**COMMITTEE OF ADJUSTMENT**

**NOTICE OF PUBLIC HEARING**  
**Minor Variance**

<b>APPLICATION NO.:</b>	<b>HM/A-22:160</b>	<b>SUBJECT PROPERTY:</b>	57 RYMAL RD W, HAMILTON
<b>ZONE:</b>	“C5, 318, T8” (Mixed Use Medium Density)	<b>ZONING BY-LAW:</b>	Zoning By-law City of Hamilton 05-200, as Amended

**HAMILTON VOLVO ADDITION**  
 57 RYMAL RD. W.  
 HAMILTON, ON

ELEVATIONS

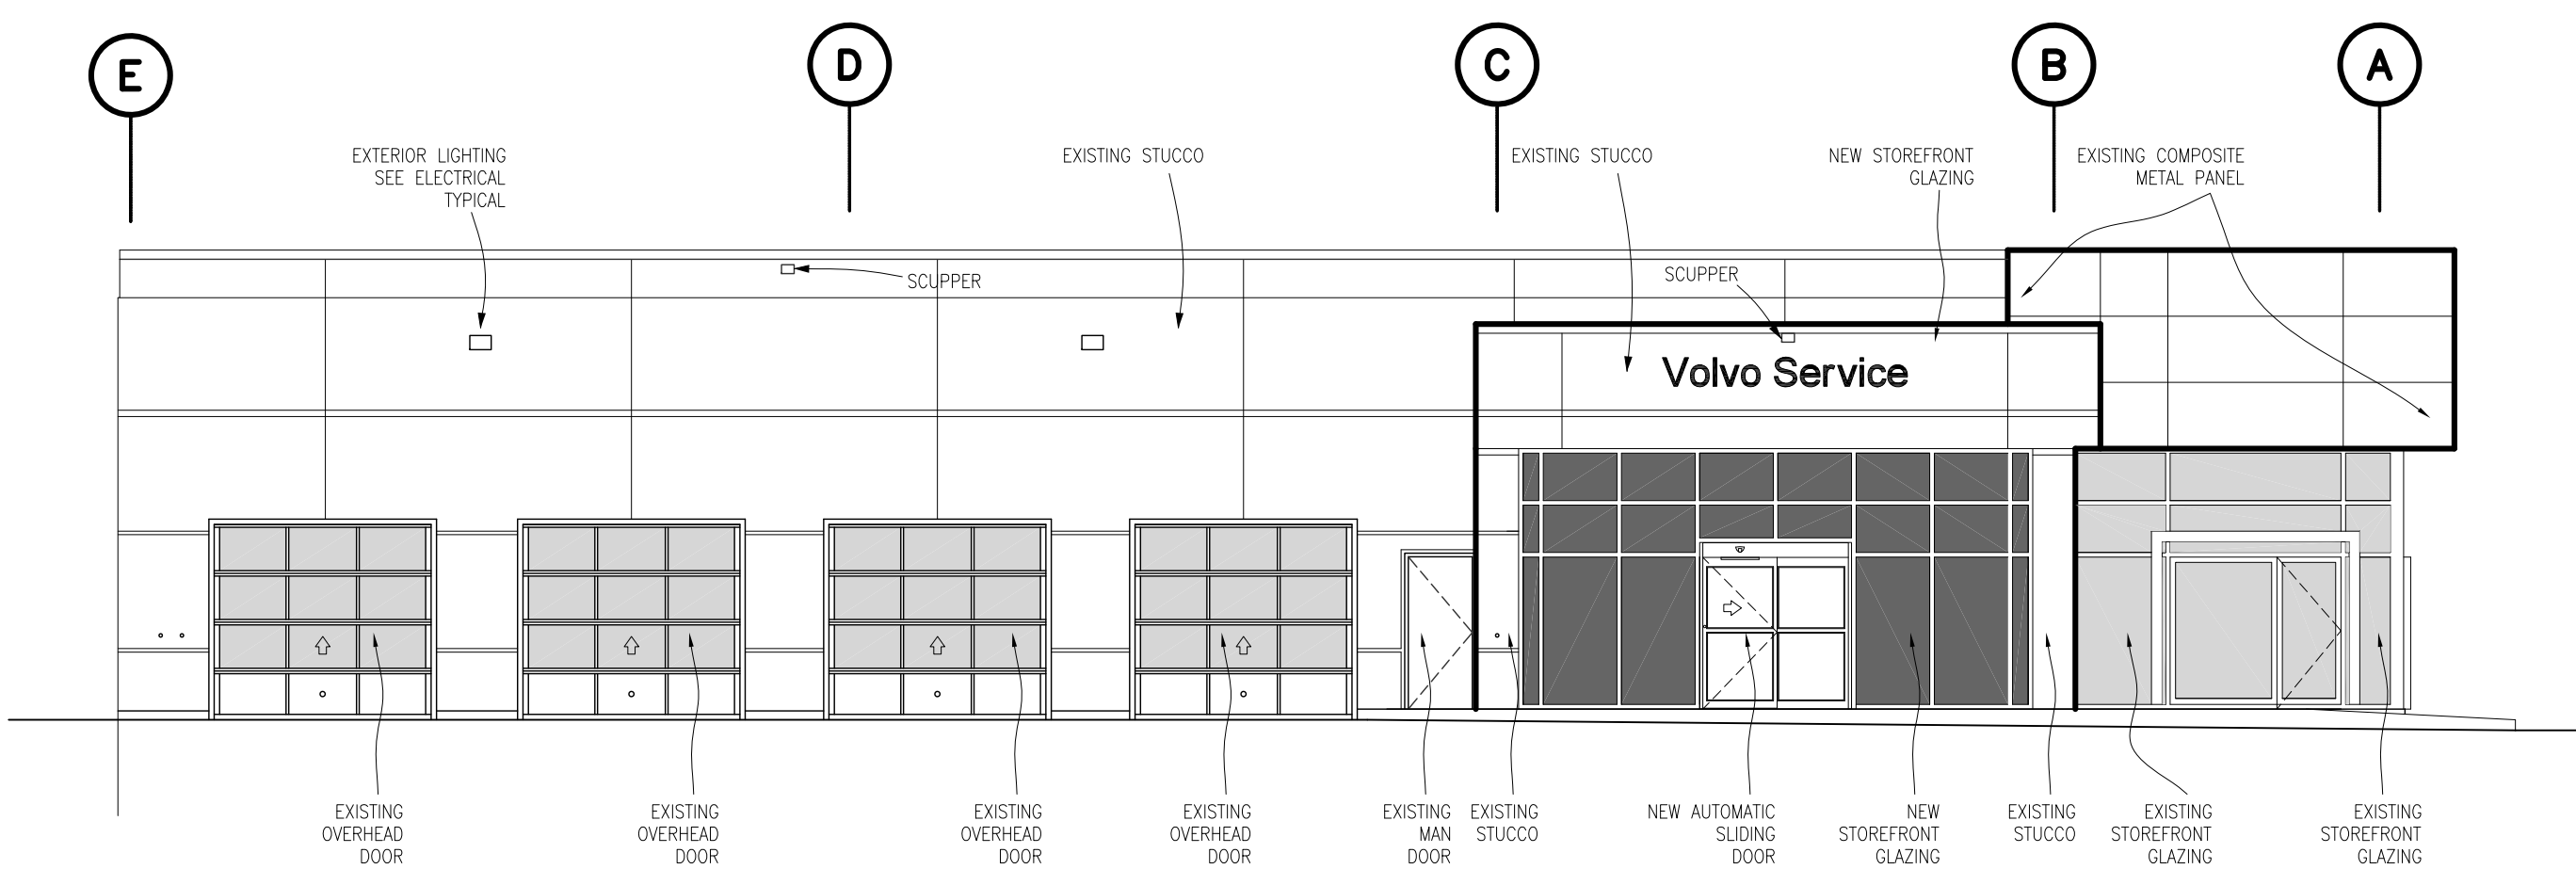
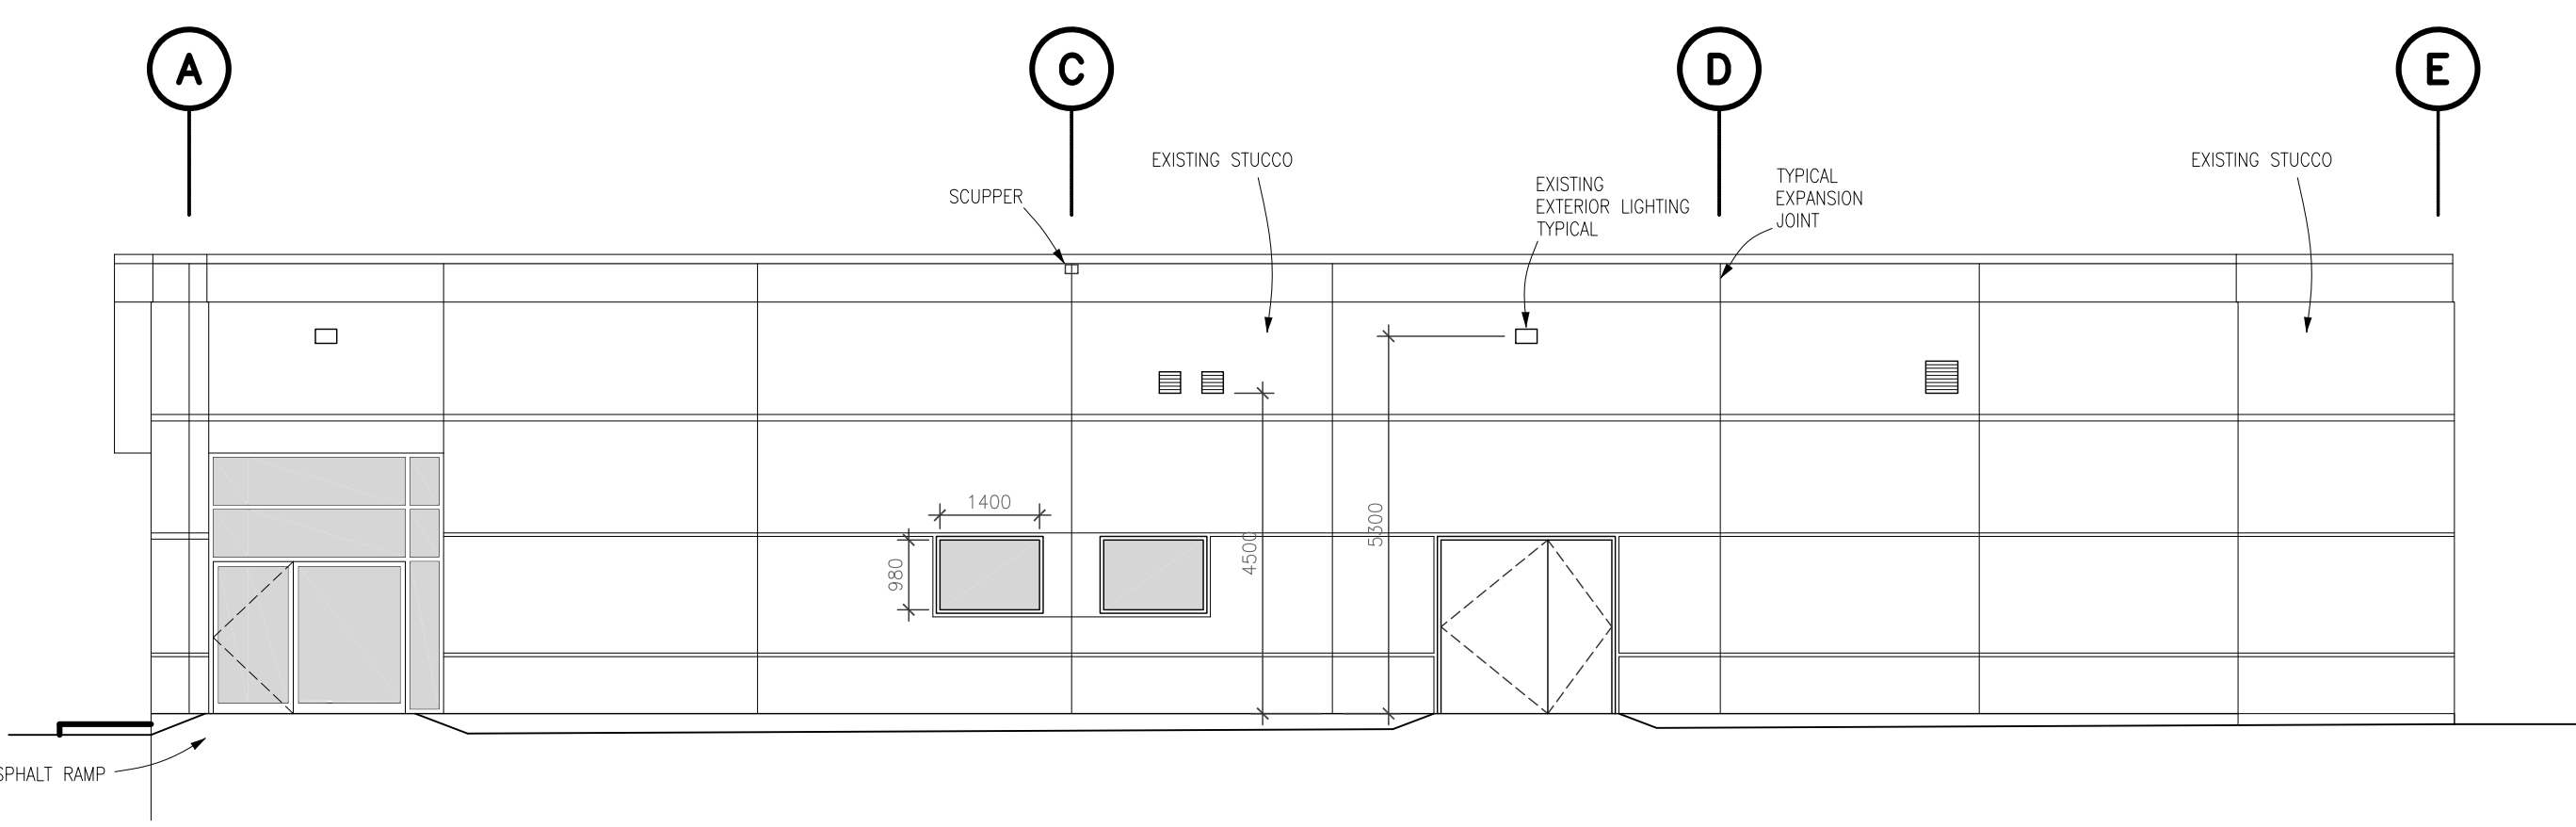
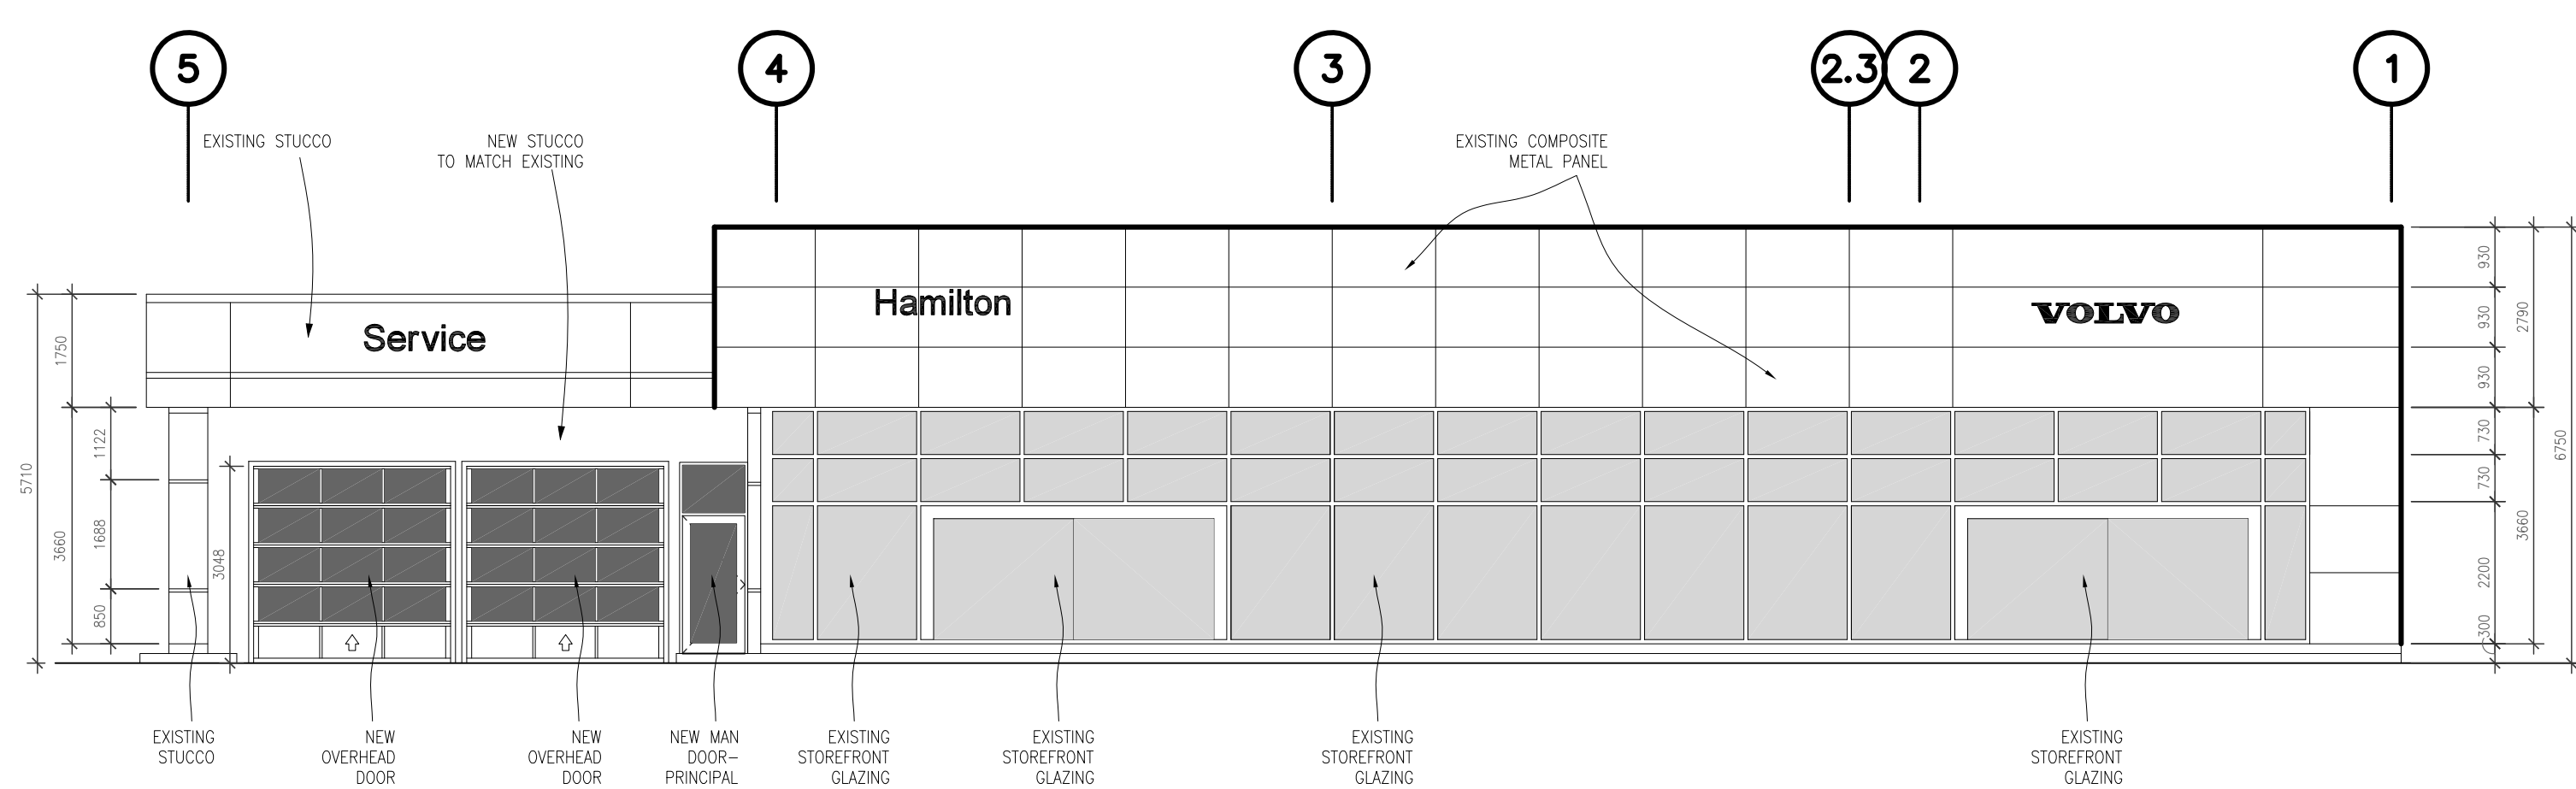
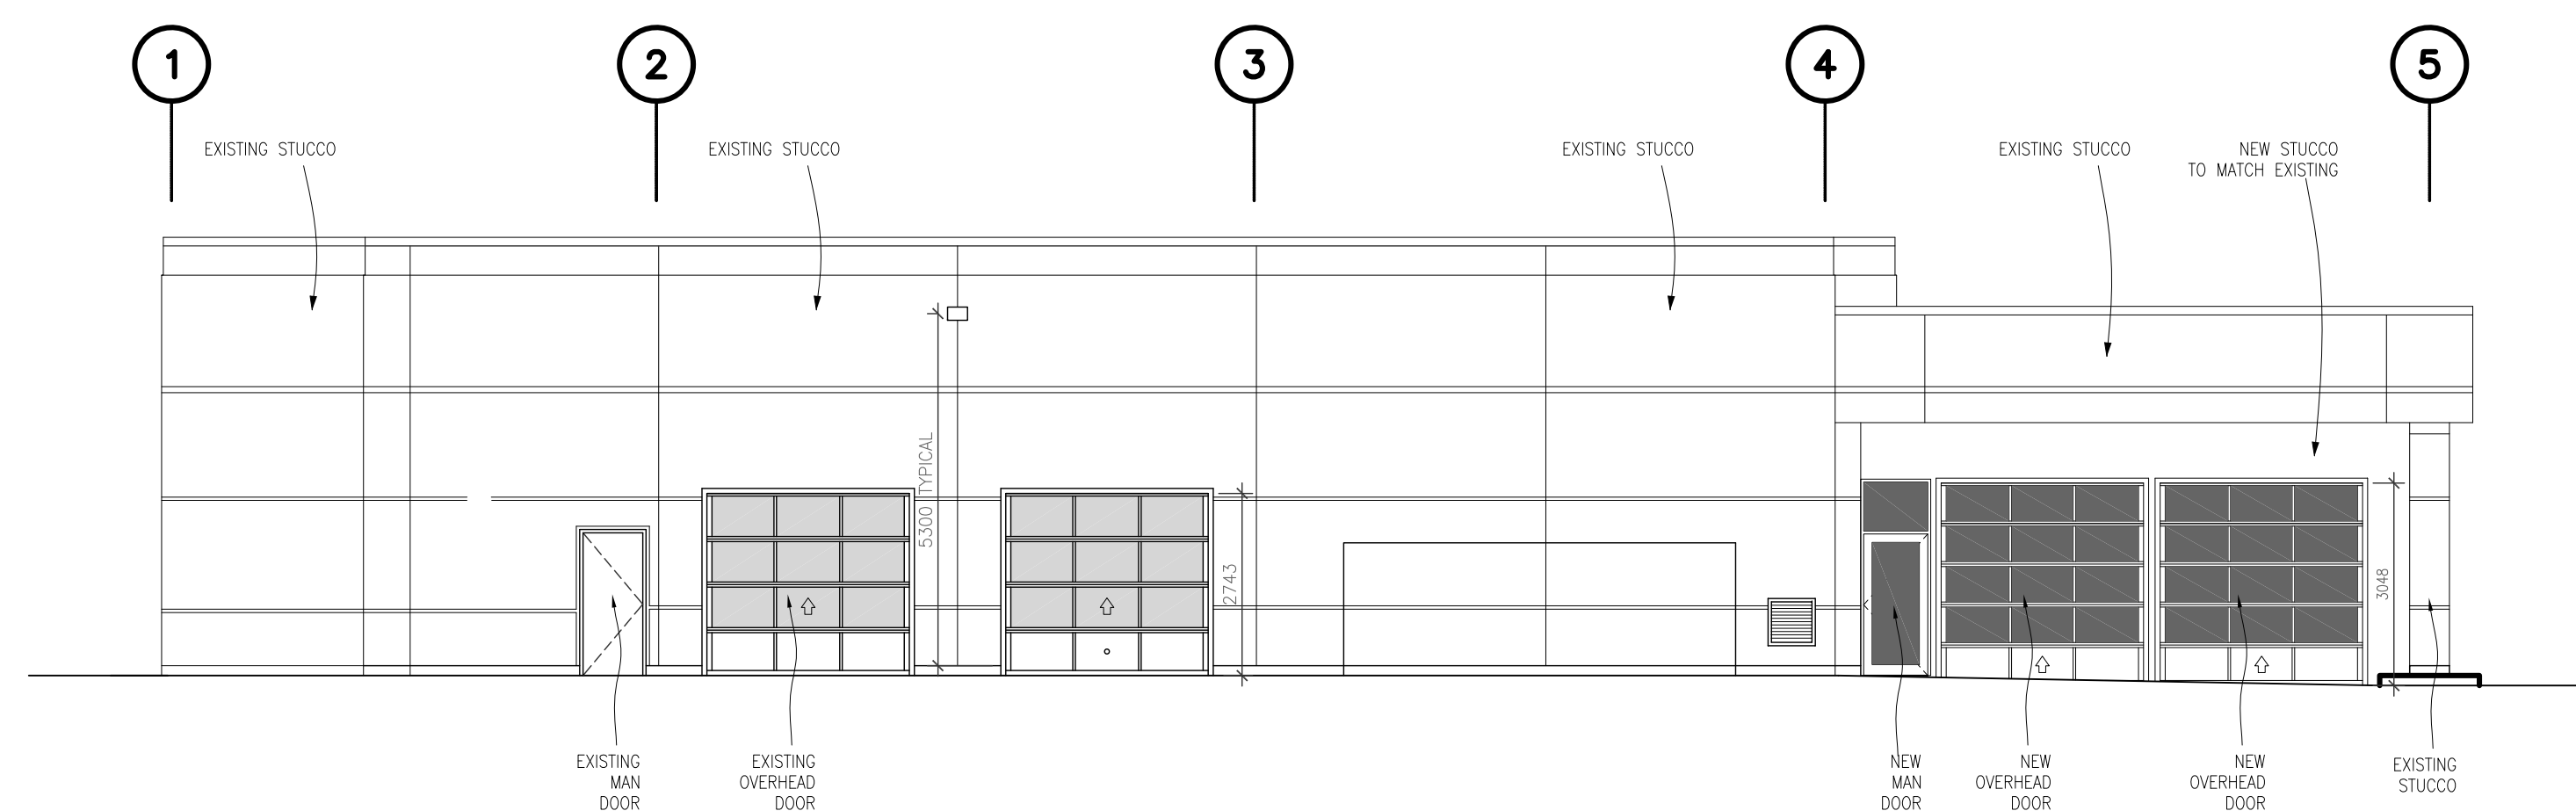
7. Please confirm if rooftop equipment is intended on the addition. If so, please show on the Elevation Plans if it is screened from view.

8. Can you please provide an Elevation Plan as the copy submitted to Committee of Adjustment staff is legible in order to determine the height of the proposed addition.

9. Please identify the location of the principal entrance on the Elevation Plan. Is it the "new man door" on the addition?

**Please note that the intent is only to heat the space via a block unit heater that is to be installed inside the space. There is no intention of cooling the space during warm days.**

**Please see drawing A2.01 attached.**

**Please note that the "new man door" has been designated as the principal entrance. This has been updated on both drawings: A1.0 Site Plan and A2.10 ELEVATIONS**
